Sub:- Minutes of 13th Meeting of Technical Advisory Group of Ken Betwa Link Project Authority on 13.08.2025 in online mode.

Minutes of 13th Meeting of Technical Advisory Group of Ken-Betwa Link Project Authority held on 13.08.2025 in online mode

**PROPOSAL FOR THE
TECHNICAL ADVISORY GROUP
FOR
TUNNEL BETWEEN RD 116.1 KM
AND RD 125.7 KM OF
KEN-BETWA LINK CANAL**

Examination of note on techno-economic comparison of constructing a tunnel section for the Ken-Betwa Link Canal between RD 116.1 km and RD 125.7 km instead of proposed open channel submitted by KBLPA

Map showing original and revised alignment with the tunnel

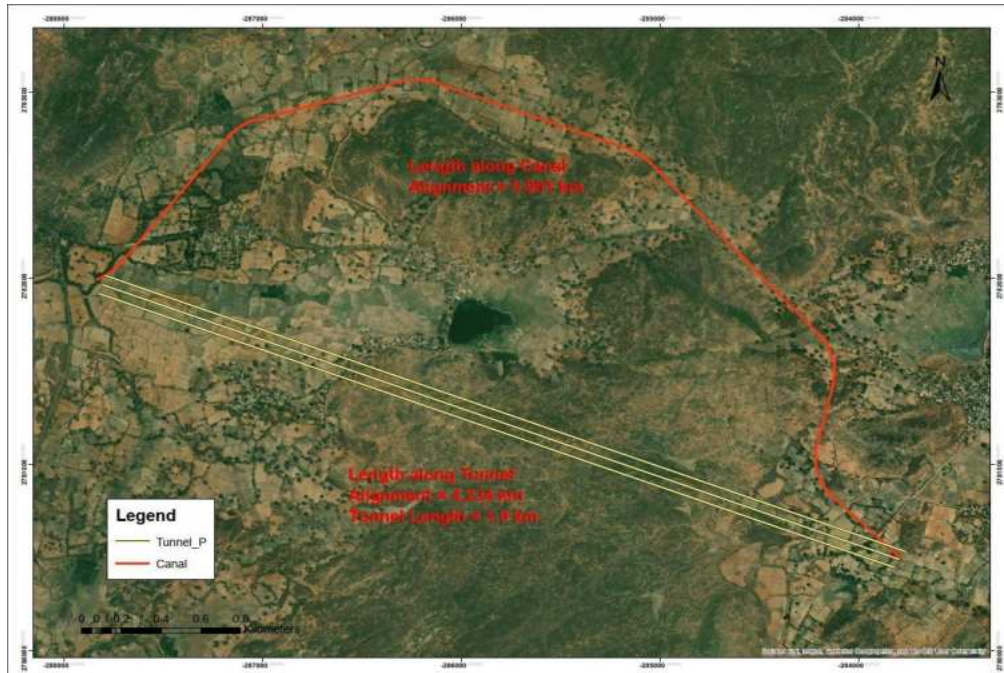
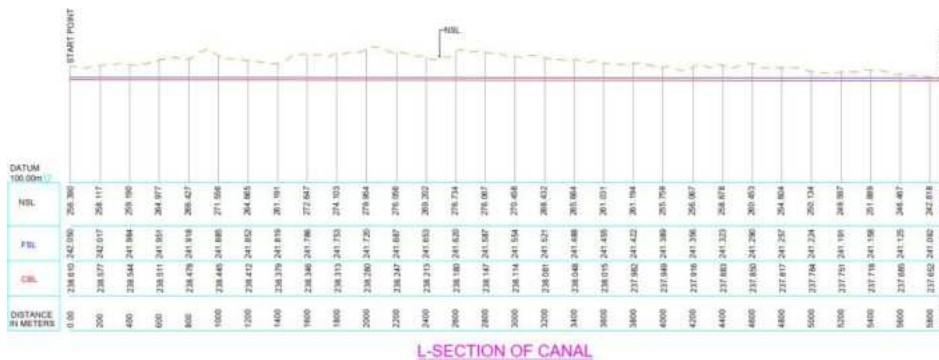
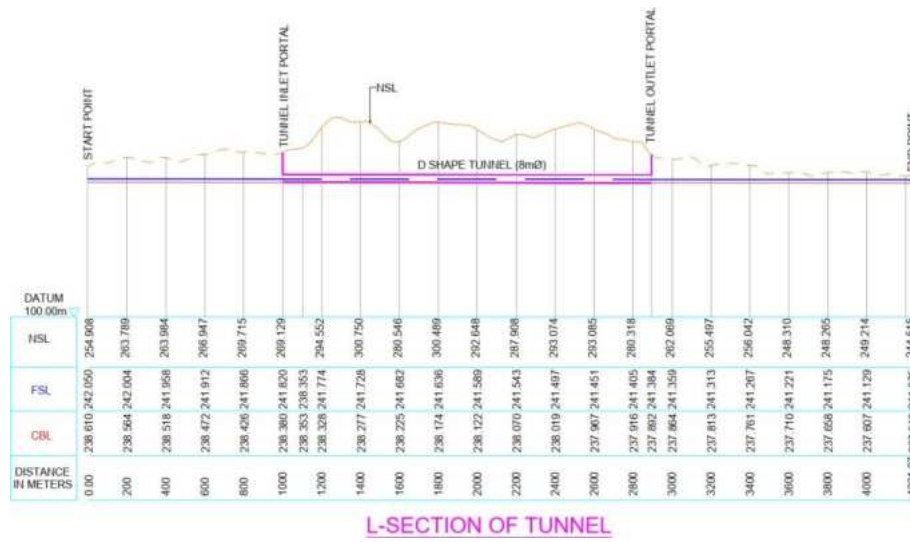
This has reference to the MOM of the 11th TAG meeting held on 9&10 May 2025 wherein the technical review of the proposed modified alignment of KBLC was carried out by TAG of the KBLPA. The TAG agreed to the proposal of Govt of MP for all the reaches except for RD 116150m to 125622m (village Ramnagar). The two alternatives presented for this reach discussed in the TAG were (1) Canal: 5.89 km and (2) Tunnel: 1.5 km + Canal :2.75km.

“The TAG noted that alignment proposed has multiple sharp bends and involves an additional length of 603 meters. The TAG also noted that there could be a straight route between coordinates E- 323029.938 N-2759607.085 and E- 319454.246 N-2760476.974, which would reduce the length of alternate alignment significantly. However, this route involves tunnel in around 1.5 km reach which may be feasible. In the light of this, the TAG suggested that the option of taking water through the tunnel/canal combination to the extent feasible may be explored between coordinates E-323029.938 N- 2759607.085 and E-319454.246 N- 2760476.974. This will reduce the length and minimize the bends in the water carrier, reduce the losses and thus will be more efficient.”

- (i) With constraints of parameters such as fixed discharge (76.23 cumec), predetermined tunnel entry and exit points (slope of tunnel), the need to match the gradient of the tunnel with that of the canal, it is hydraulically feasible to convey the required discharge only either through a single large-sized tunnel or through twin smaller-sized tunnels. However, both these options shall be cost-intensive and time-consuming from a construction perspective.
- (ii) It is also mentioned in the note that the CEO (KBLPA), ACEO (Canal) and officers from the WRD, GoMP and KBLPA officials visited the site to evaluate the feasibility of construction of tunnel near Ramnagar/Charee village in Tikamgarh District. The team after inspection of the site observed and indicated potential technical and financial challenges associated with choosing tunnel construction in place of open canal.

- (iii) Further, it has been mentioned in the note, that the geology of the strata through which the tunnel is proposed to traverse comprises of weathered and fractured granite and suggests challenging excavation conditions and potential stability issues during construction. To confirm the above, additionally geo-technical investigations would be required for the tunnel design, which would further add to the time requirement of the project.

- (iv) The cost comparison submitted by KBLPA - for Proposal 1 is about **₹57.89 crores** (Canal of 5.901 km) and for Proposal 2 is approx **₹204.90 crore** (twin tunnels of 1.90 km - ₹182 crore and Canal of 2.334 km - ₹22.9 crore). However, the cost of land acquisition in case of proposal 1 has not been considered.

- (v) Furthermore, the proposal 1-open canal alignment has the operational advantages like easier maintenance, direct accessibility for inspections, greater flexibility for future upgrades, lower long-term maintenance costs and at the same time flexibility in allowing discharge adjustments as demand evolves in future, requires serious consideration.

From the above information/data submitted by KBLPA, it is inferred that the proposal -2 (tunnel + canal), though hydraulically feasible, is cost-intensive and time-consuming from the construction perspective. The difference in construction cost of the two proposals, as submitted by KBLPA, is appreciable though the land acquisition cost (not considered) may narrow down this difference in the total cost.

Therefore, in view of the above it is opined that the TAG may consider and opt for the open channel alternative-1 considering the advantages of open canal and constraints in hydraulic design of the tunnel in the instant case.

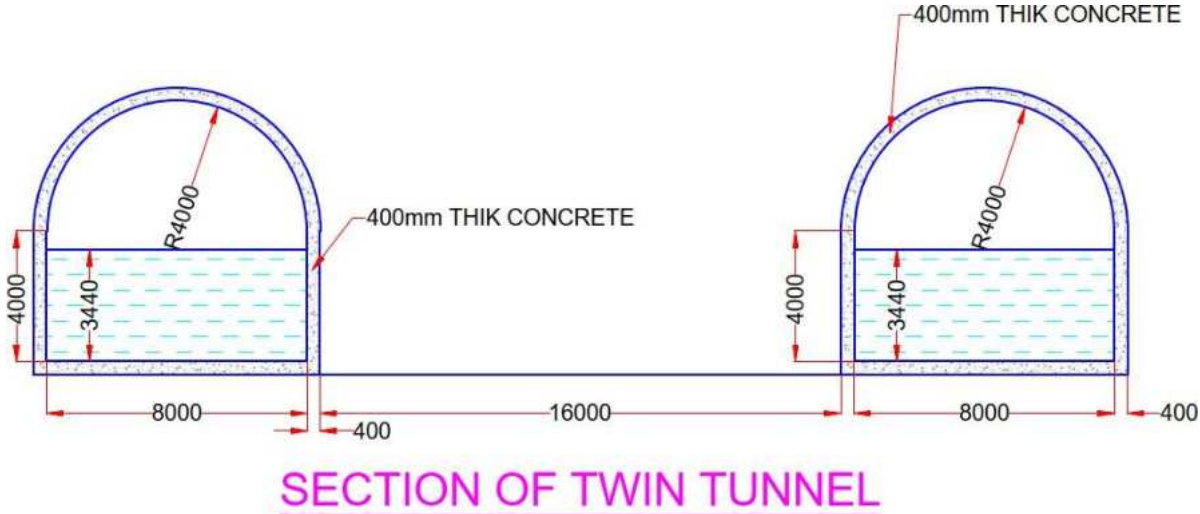
- v. To prevent silt deposition issues, the tunnel flow depth has been considered limited to 3.44 meters, matching the canal's design depth. This constraint necessitates a tunnel bed width of 15.50 meters. However, constructing a single tunnel of 15.50 meters diameter presents significant technical challenges and may not be practically feasible.

- vi. Consequently, the study evaluated twin tunnel configuration with 8-meter diameter specifications may be considered as an alternative. This approach would provide equivalent hydraulic capacity while utilizing more conventional tunneling methodologies and equipment.
